Contract No. T201804301.01
Federal Aid Project No. NH-S018(18)
Georgetown East Gateway Improvements
Sussex County

Enclosed is Addendum No. 2 for the referenced contract consisting of the following:

CONTRACT T201804301	BRIDGE NO.	SIGNING, STRIPING, AND CONDUIT PLAN	SS-06
COUNTY SUSSEX	DESIGNED BY: AFD		SECTION WRA
	CHECKED BY: MJB		SHEET NO. 153

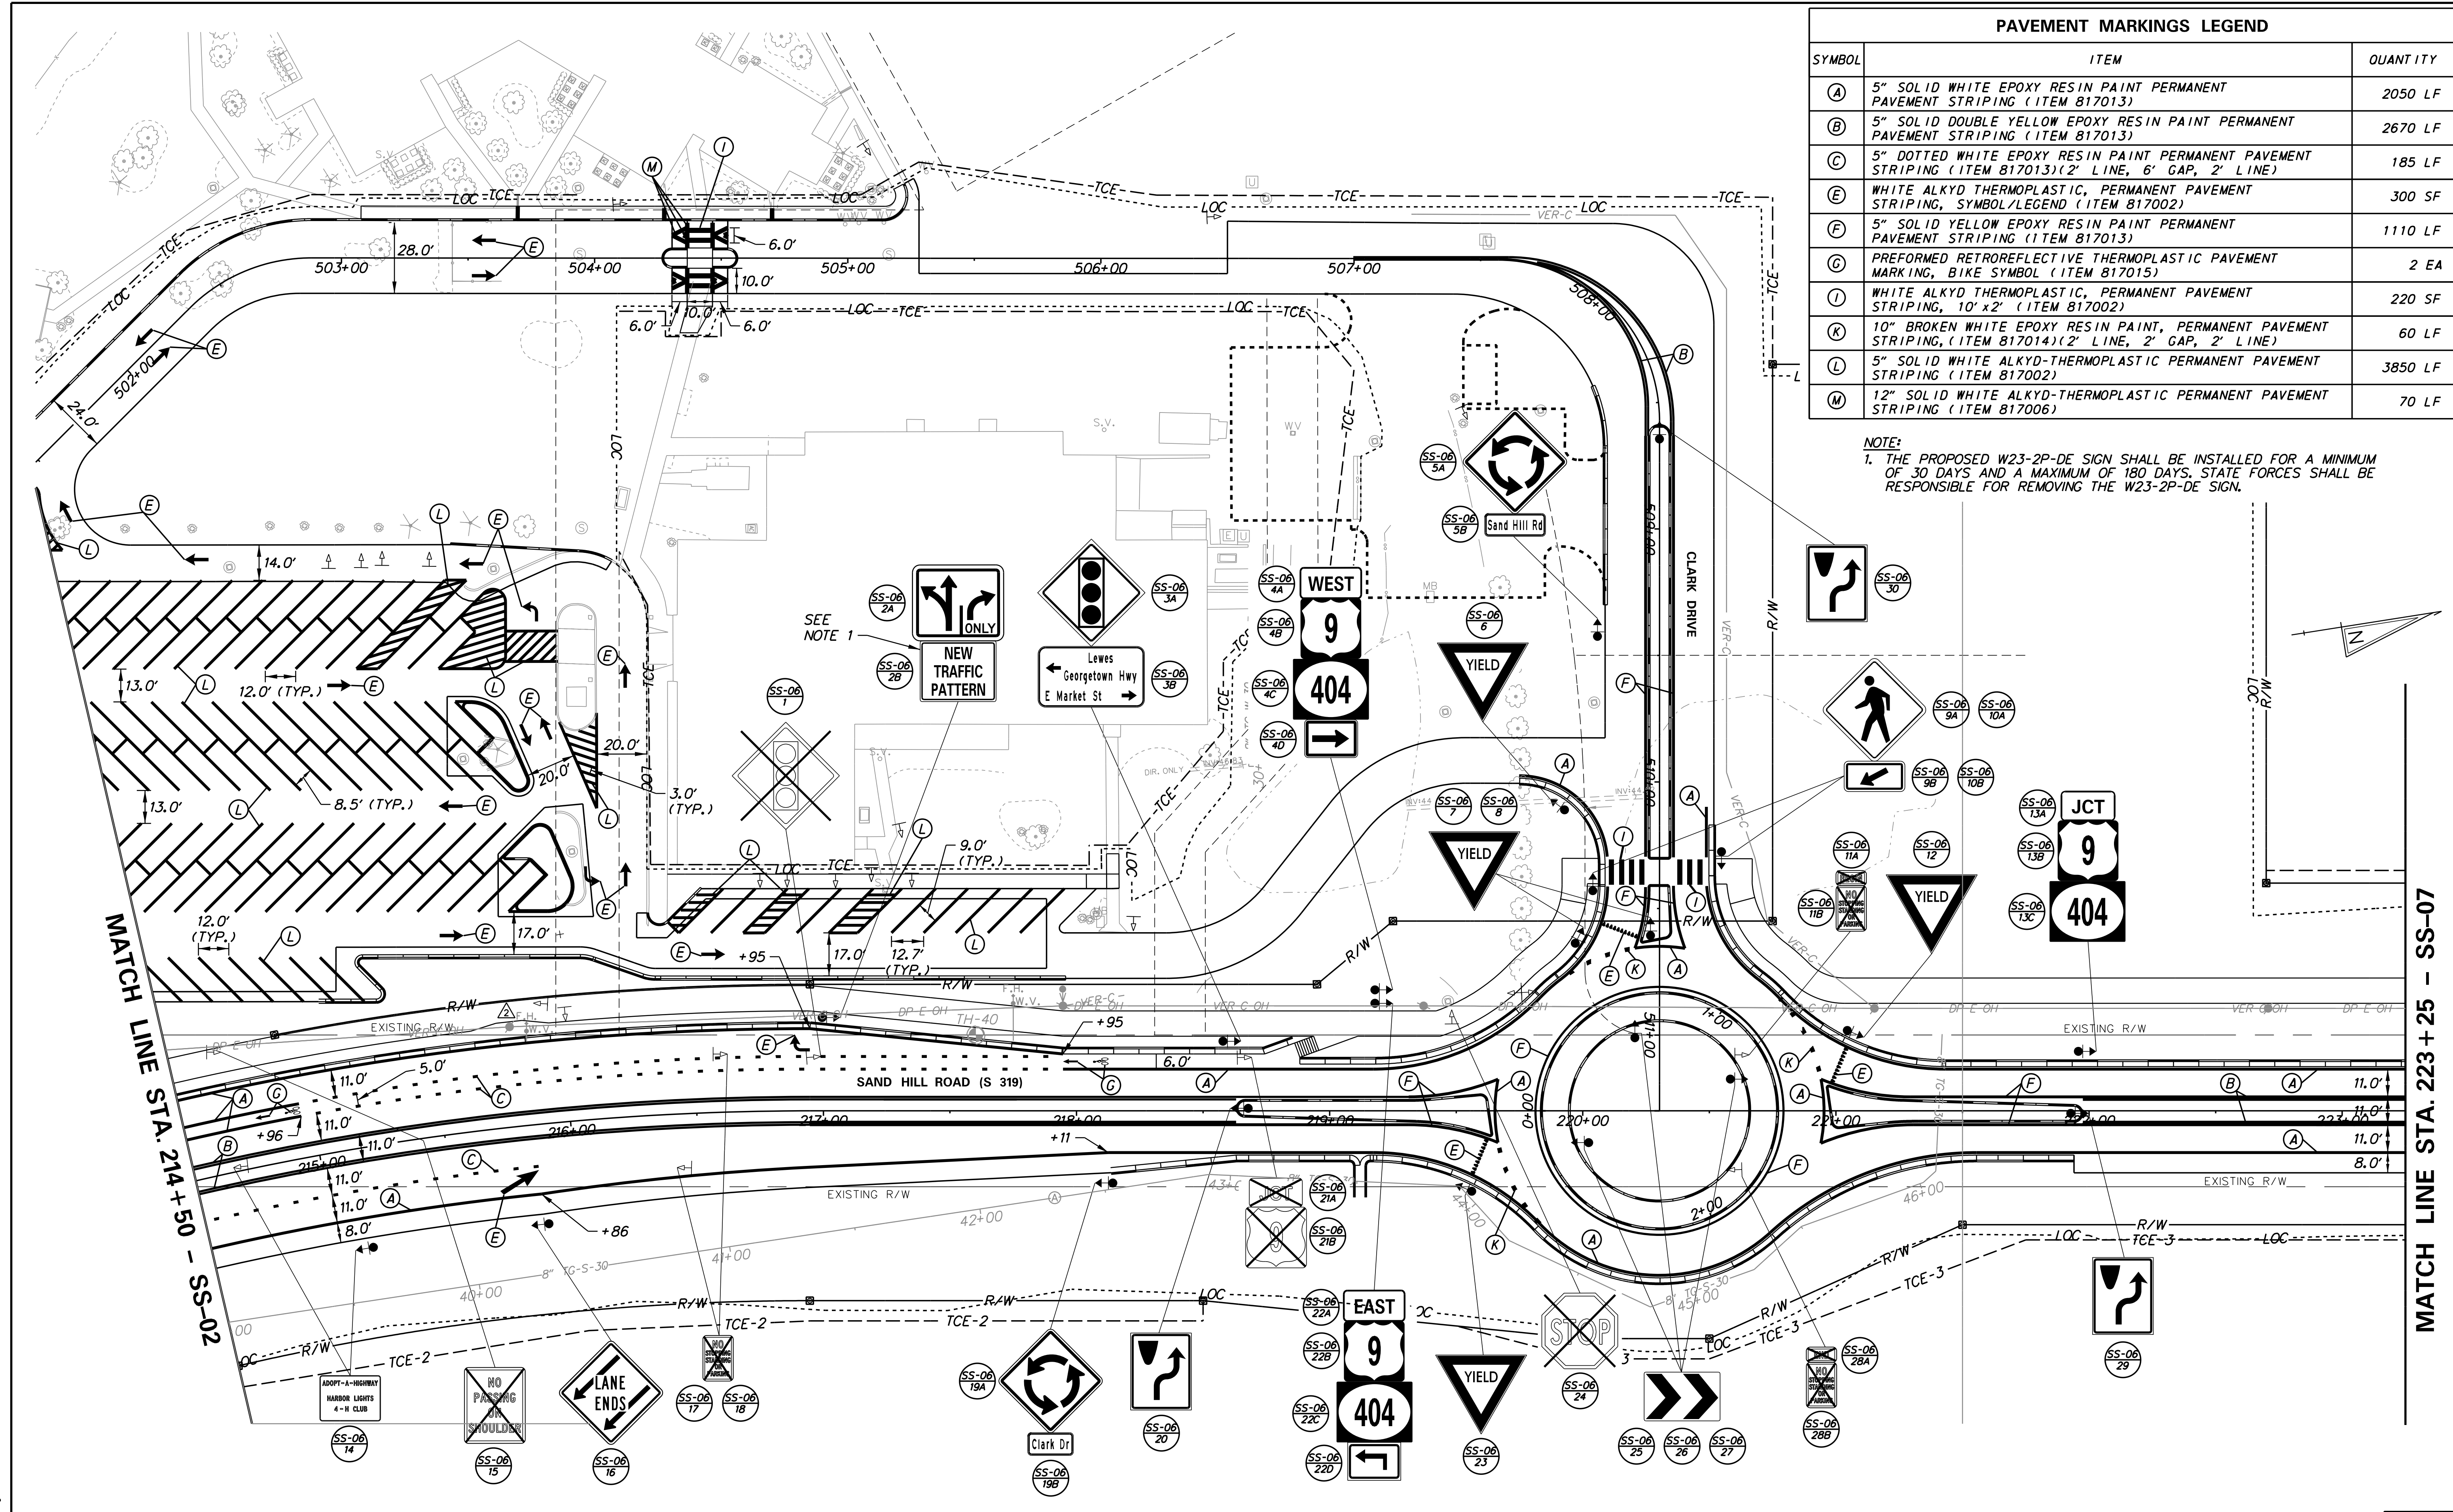
ADDENDA / REVISIONS
ADDED FIRE HYDRANT AND WATER VALVE, R. WILLS - 5/1/20
